Imarda NZ Ltd

16th July, 2015

I am confirming the physical and electrical variances between the V301-336-IW-030 and V301-336-XWP-030 Telematics devices are as follows:

CPU

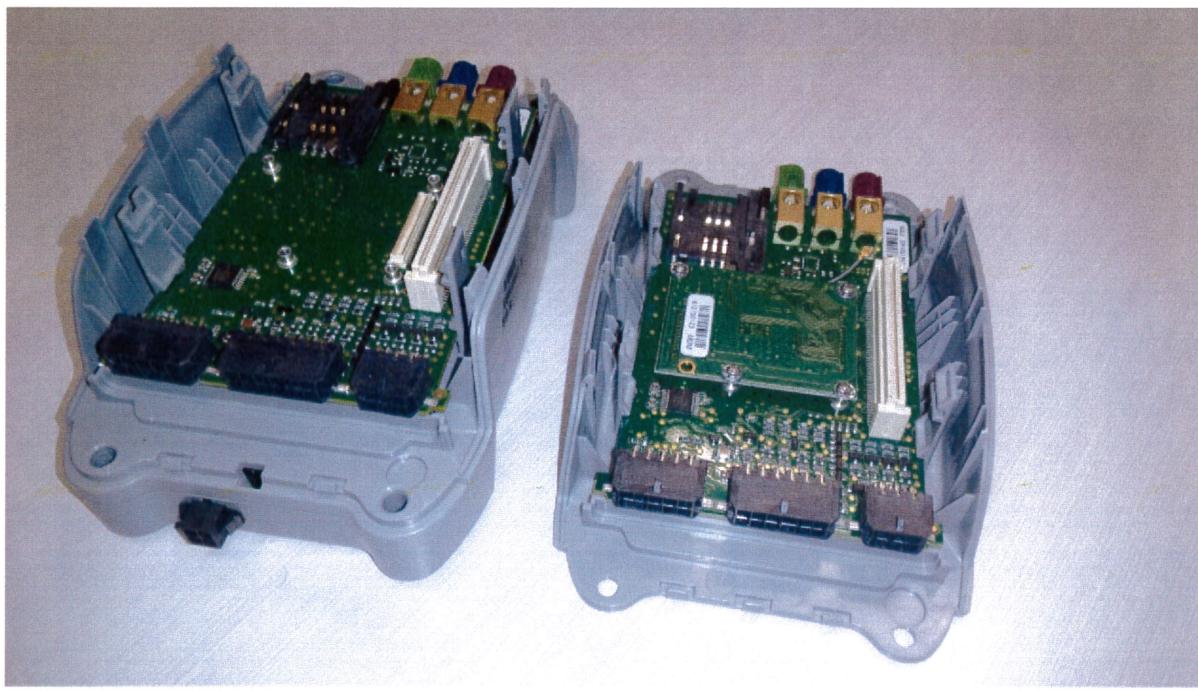
Internally, the 2 models contain identical CPU and FMX PCB assemblies, within the IW variant the cellular modem is clipped onto the FMX board via a connector and retained with screws, the XWP variant has the cellular modem module removed and features an additional PCB assembly which contains additional circuitry for PLC (no Radios on the PLC board). Side by side photos of the internals of both products are shown below (XWP on left):

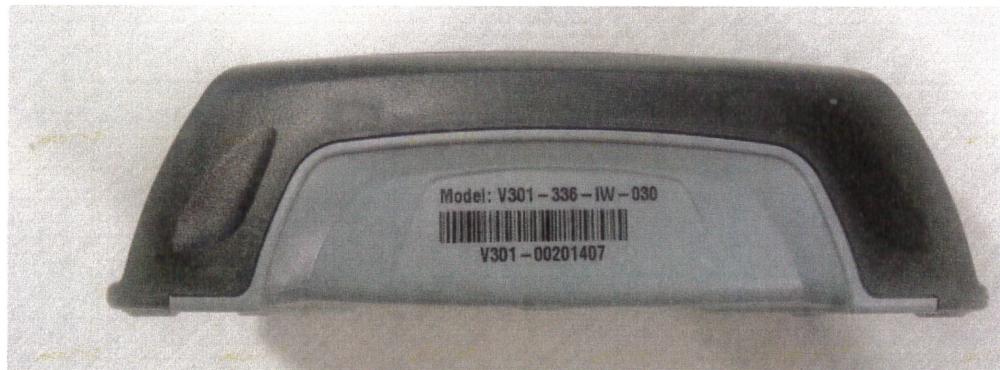
Externally the XWP variant is slightly taller (20.4mm) in order to house the additional PLC circuitry, all other dimensions remain the same, and photos are included below to illustrate the difference in height.
